**SUNDRY NOTICES AND REPORTS ON WELLS**  
**Do not use for proposals to drill or to re-enter an abandoned well. Use Form 3160-3 (APD) for such proposals.**

8. Well Name and No.  
Mescalero Ridge Federal #3

## WELL COMPLETION SKETCHES SLN-5036-4-A

**Mescalero Ridge Federal 3  
30-025-29471  
Seely Oil Company  
December 06, 2016  
Conditions of Approval**

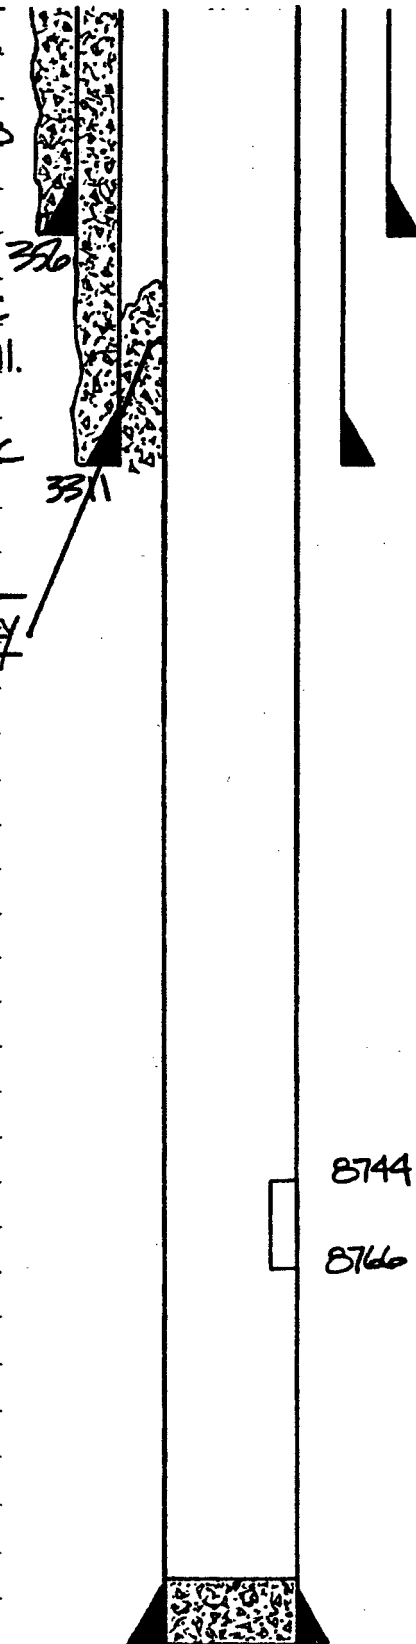
MI & RU CU. TOH w/ rods & tbg  
Set CIBP @ 8500' w/ 35' cmt on top. *missing plugs See COAs*  
Set CIBP @ 5000' (above Grayburg / San Andres) w/ 35' cmt on top.  
Performate from 4384 - 4390' w/ 2 spf. TIH w/ tbg & pkr.  
Acidize w/ 750 gallons 7 1/2 % MCA.  
Fracture treat w/ 20,000 gals. gelled KCL w/ 35,000lbs sand.  
Recover load. TOH w/ tbg & pkr.  
TIH w/ rods & tbg. Return well to production.

*Plugs added see COAs*

- 1. Operator shall place CIBP at 8,644' (50'-100' above top most perf) and place 35' of Class H cement on top as proposed. WOC and tag.**
- 2. Operator shall place a solid Class C Cement plug from 6,966'-6,796' to seal the top of the Bone Spring formation.**

- 3. Operator shall place a solid Class C Cement plug from 5,962'-5,802' to seal the top of the Delaware formation.**
- 4. Operator shall place a CIBP at 5,000' with 35' Class C Cement on top as proposed. WOC and tag.**

- 5. Must conduct a casing integrity test before perforating and fracturing. Submit results to BLM. The CIT is to be performed on the production casing to max treating pressure. Notify BLM if test fails**
